TENNESSEE VALLEY AUTHORITY (TVA) – GALLATIN FOSSIL PLANT (GAF) –
COMMISSIONER'S ORDER NUMBER OGC19-0004 – NON-REGISTERED SITE (NRS)
#83-1324 FIELD DEMONSTRATION WORK PLAN REVISION 1.

TVA has revised the NRS Field Demonstration Work Plan in response to comments from TDEC in a letter dated July 20, 2021. Enclosed are both the response to comment matrix and the Revision 1 of the NRS Field Demonstration Work Plan.

TVA GAF NRS Treatability Field Demonstration Work Plan
Summary of Comments

AECOM		Figure 2	
NRS FIELD DEMONSTRATION PERFORMANCE MONITORING LOCATIONS			
DRAWN BY:	REVIEWED BY:	APPROVED BY:	REVISION NUMBER:
CARRIE.SMITH	C.GARLINGTON	E.PERRY	REV. 0
GALLATIN FOSSIL PLANT TENNESSEE VALLEY AUTHORITY			
DATE:	DEPT:		
5/12/2021	FOSSIL AND HYDRO ENGINEERING

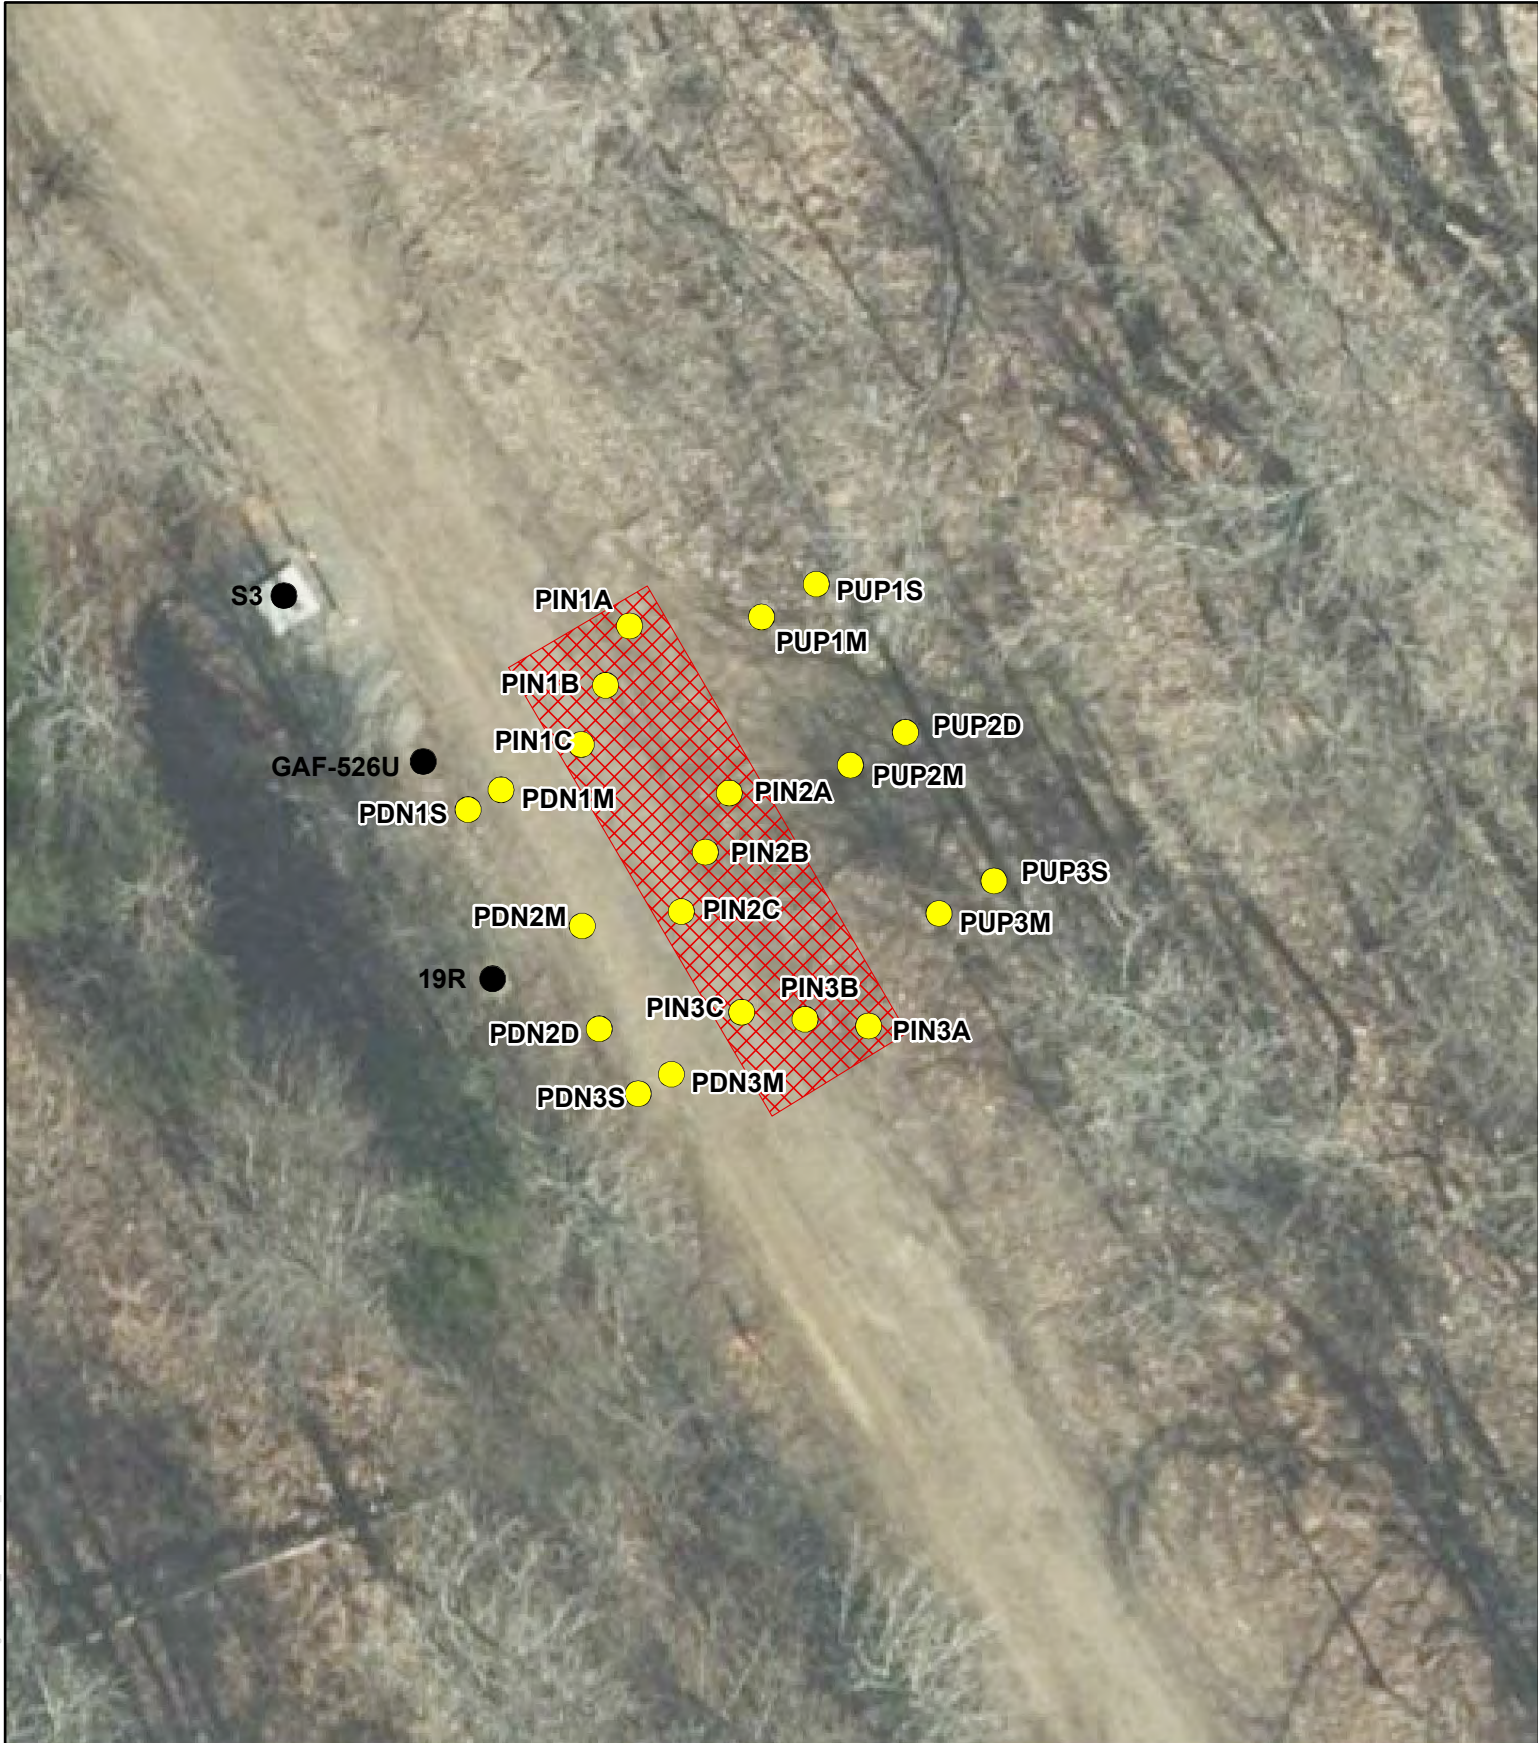
6	Appendix A	NRS Field Demonstration Performance Monitoring Plan	43/171 and 51/171	Section 2.0 and Table 1	NA	<p>Comment: Please include an explanation of the nomenclature for the well IDs indicated with a 'D', 'M', and 'S' for the PUP and PDN wells.</p> <p>TVA Response: S, M, and D designate the relative depths of the monitoring wells, indicating shallow, intermediate, and deep depths, respectively. This explanation has been added to Sections 5.1.1 and 5.1.3 of the Workplan and Section 2.0 and Table 1 of the PMP.</p>

TVA GAF - NRS Permeable Reactive Barrier Wall Section X-X'

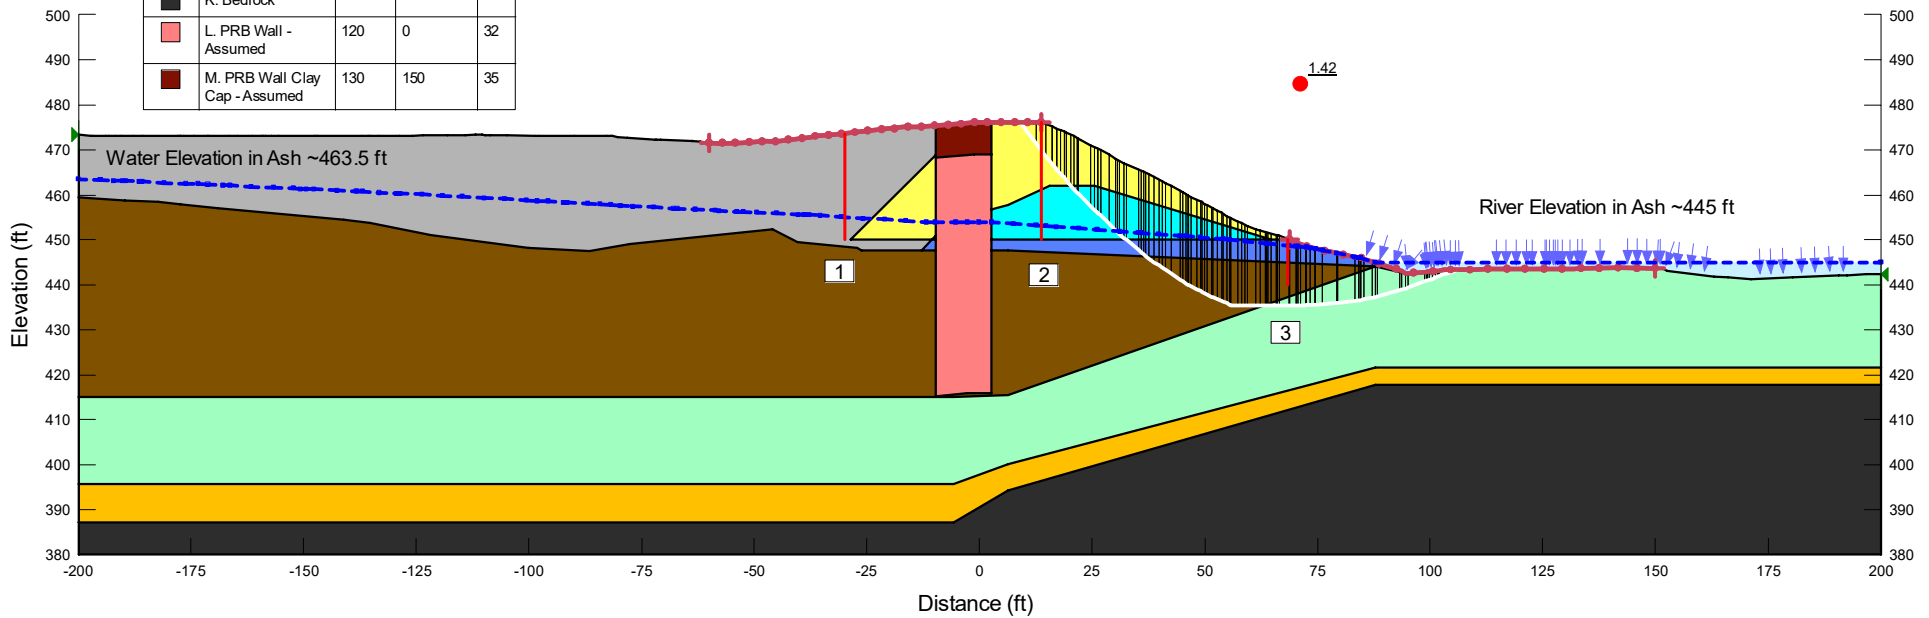
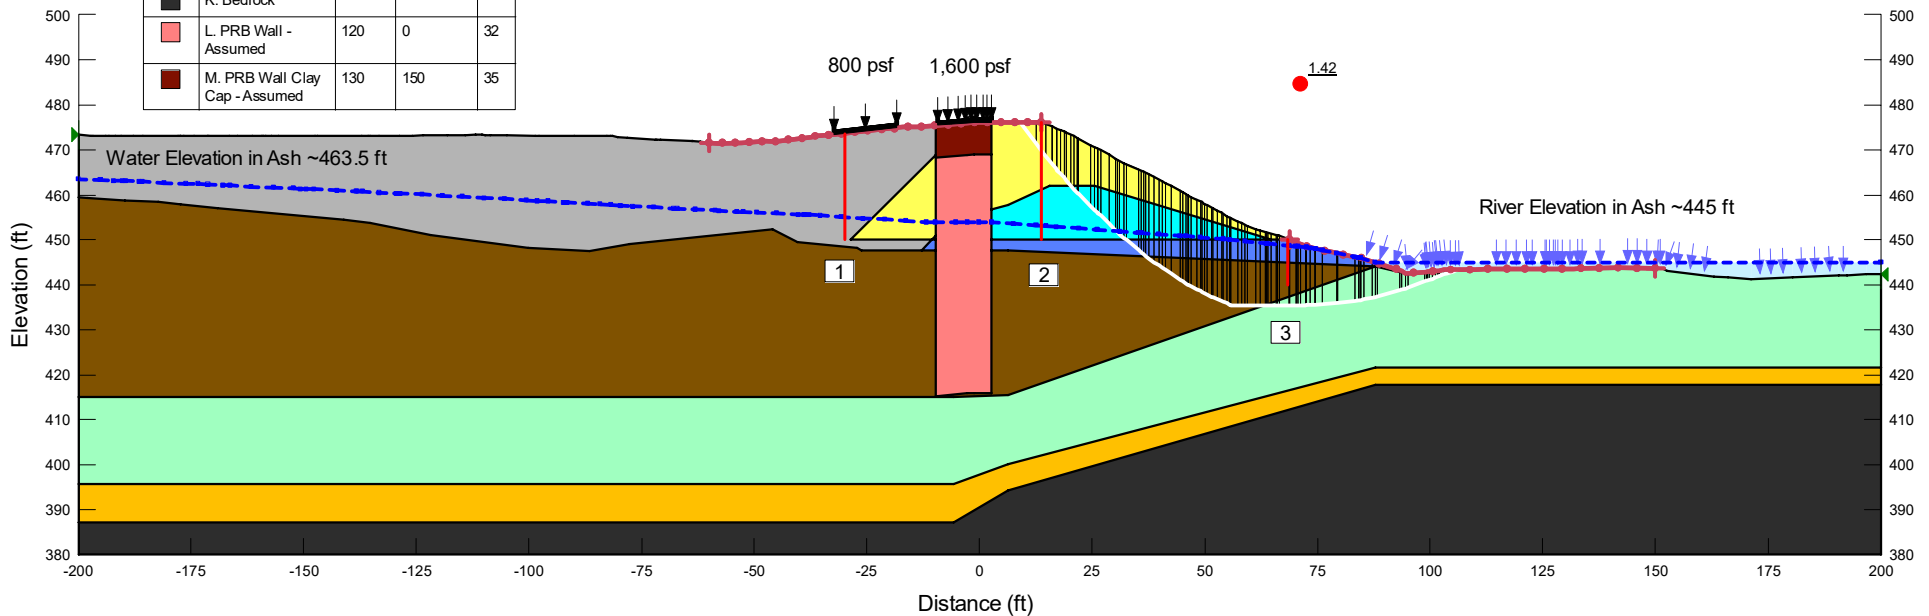
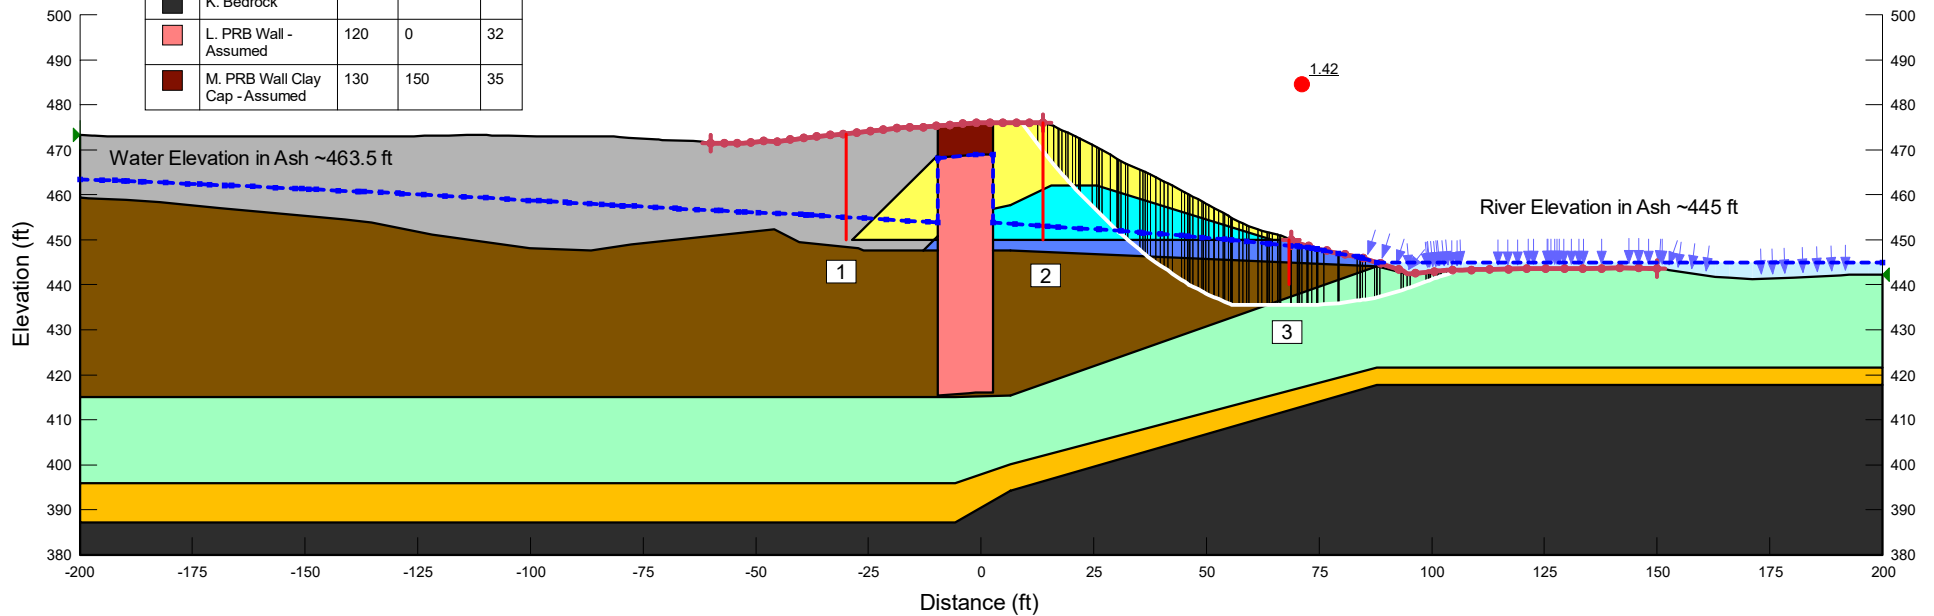
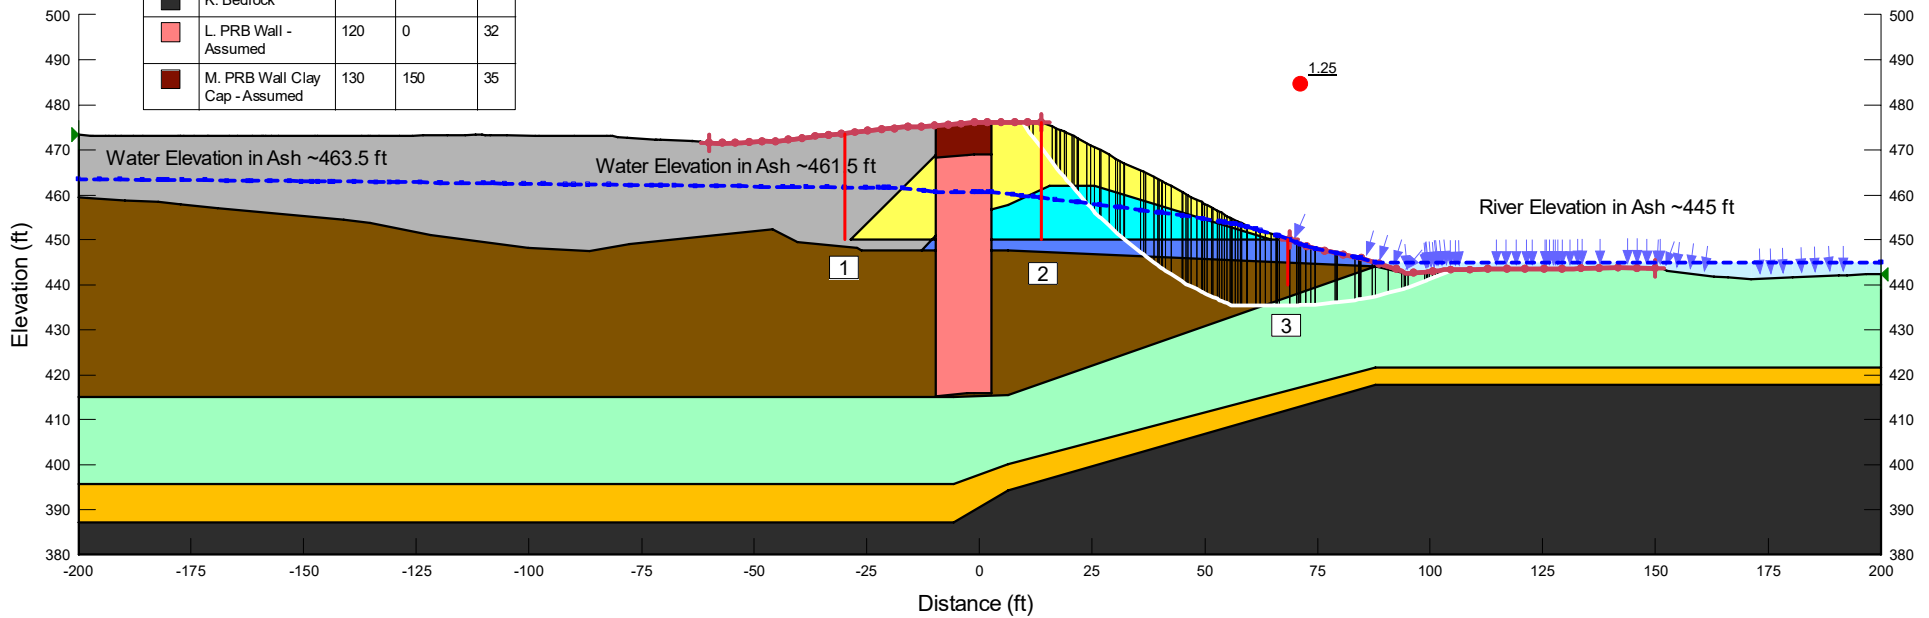
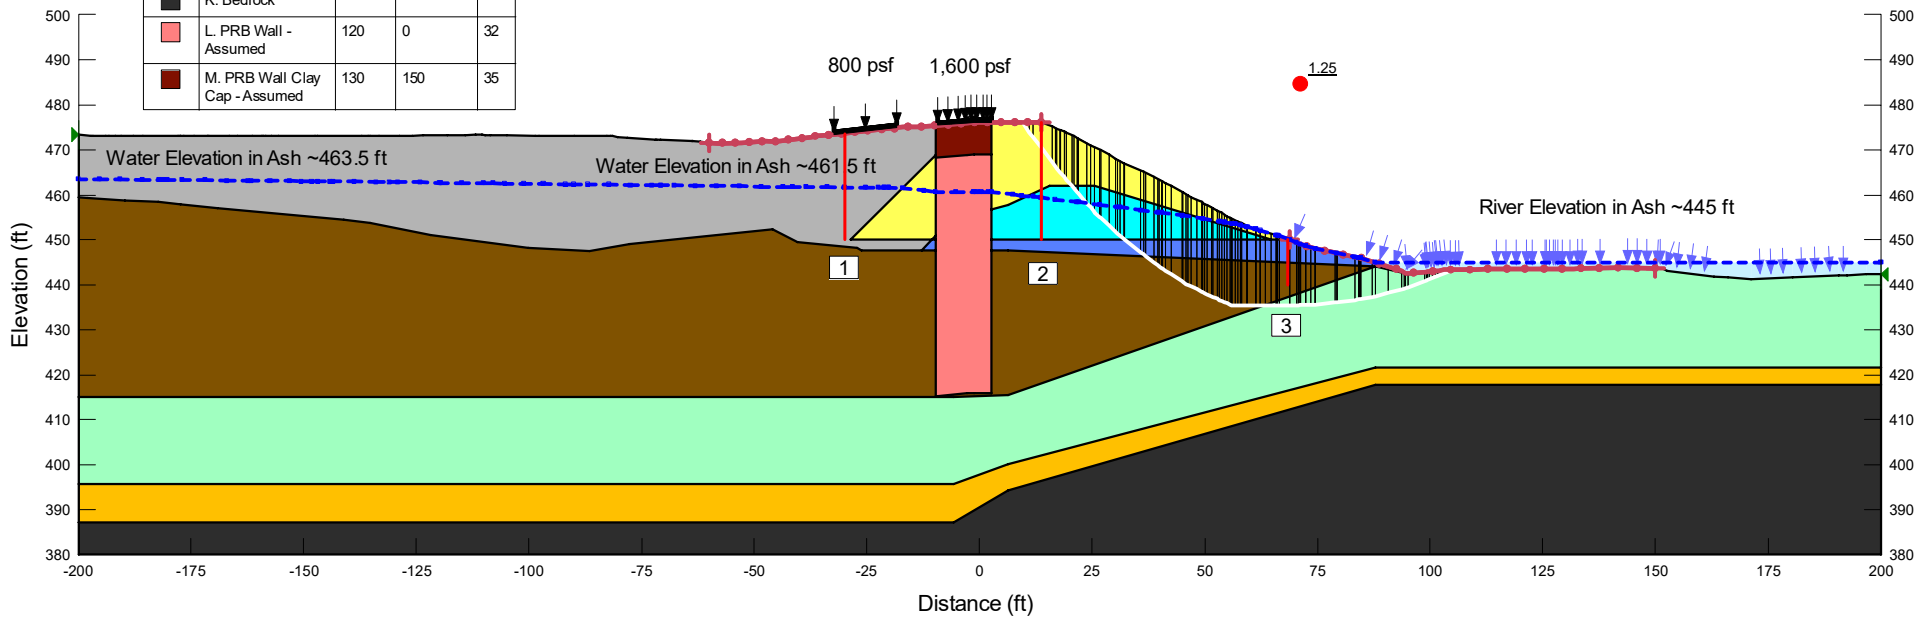
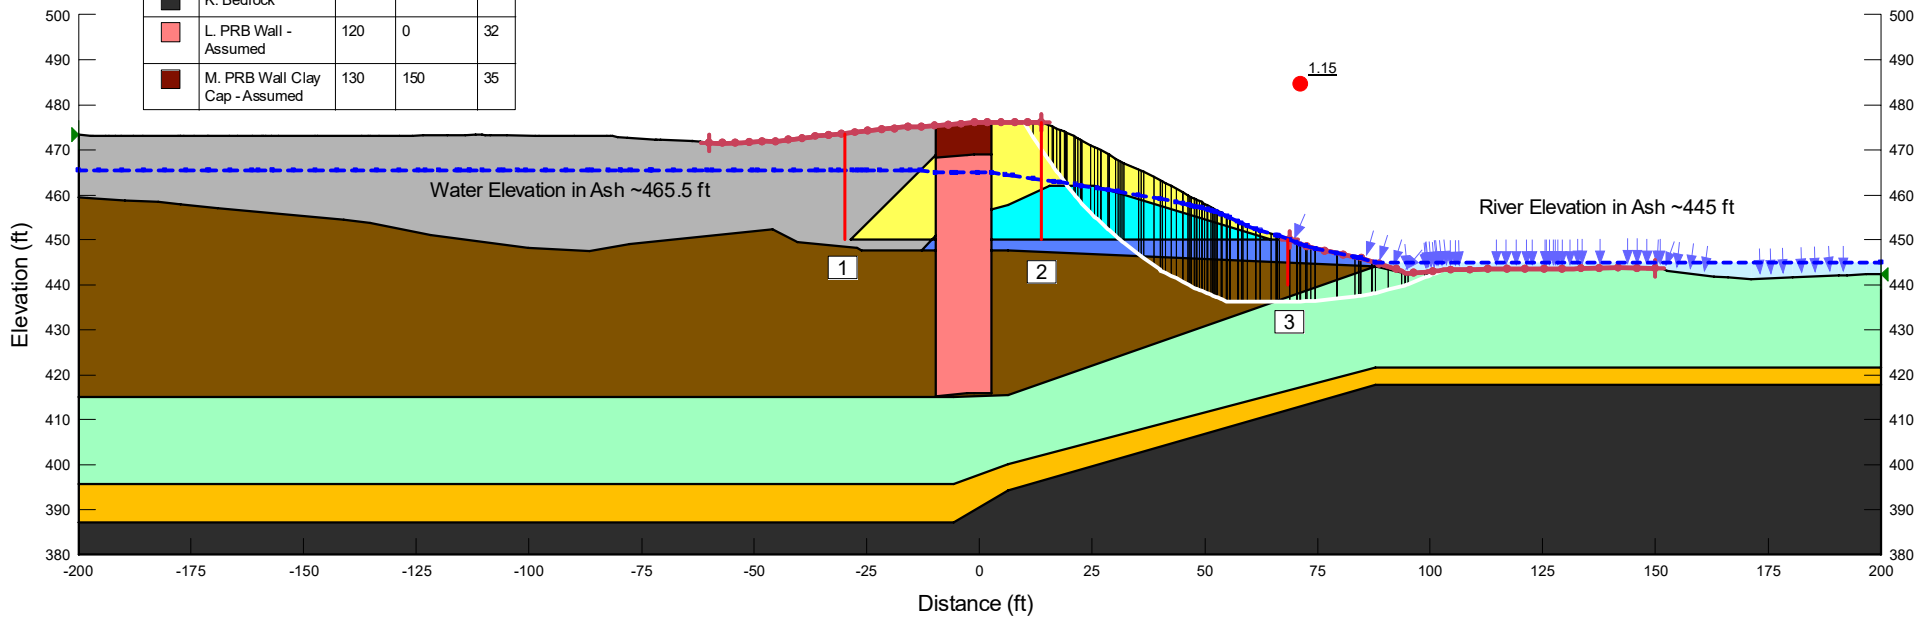
No.	Section Number	Section Title	Page	Paragraph	Line	TDEC Comment dated 7/20/2021 and TVA Response
22	Table 1	Summary of Selected Design Strengths	NA	NA	NA	Comment: <u>CCR</u> : A unit weight of 90 pcf seems low and a phi of 42 seems very high for a material described as a non-plastic silt. TDEC recognizes that CCR is well away from the critical failure surfaces, so assumptions regarding these parameters are unlikely to impact results. TVA Response: See response to comment #21.
23	Table 1	Summary of Selected Design Strengths	NA	NA	NA	Comment: <u>Final Raise</u> : A unit weight of 132 pcf is surprisingly high for a clay soil, particularly one described as a "slightly over consolidated" lean clay. Also, a phi value of 35 is toward the high end of values typically used for the drained strength of clay. It should be noted that a cohesion of zero is likely conservative. As the primary driving force of the critical failure surfaces appear to be the weight of the embankment clay layers, analyzing with a lower unit weight would be expected to increase safety factors. TVA Response: See response to comment #21.

24	Table 1	Summary of Selected Design	NA	NA	NA	Comment: <u>1958 Raise</u> : See comments above for unit weight and phi values. Please note that this layer is described as "normally consolidated" (which may be possible in part of the embankment due to significant overburden). TVA Response: See response to comment #21.
25	Table 1	Summary of Selected Design Strengths	NA	NA	NA	Comment: <u>Initial Embankment</u> : See comments above for unit weight and phi values. TVA Response: See response to comment #21.
26	Table 1	Summary of Selected Design Strengths	NA	NA	NA	Comment: <u>Lower Alluvium</u> : It is surprising to see a lower unit weight for a soil layer described as "moderately to highly over consolidated", suggesting that it is more over consolidated than overlying layers (which suggests that its unit weight should be higher). Given the location of this layer in the critical failure surfaces, unit weight assumptions probably don't impact the calculated safety factors much, if at all. TVA Response: See response to comment #21.
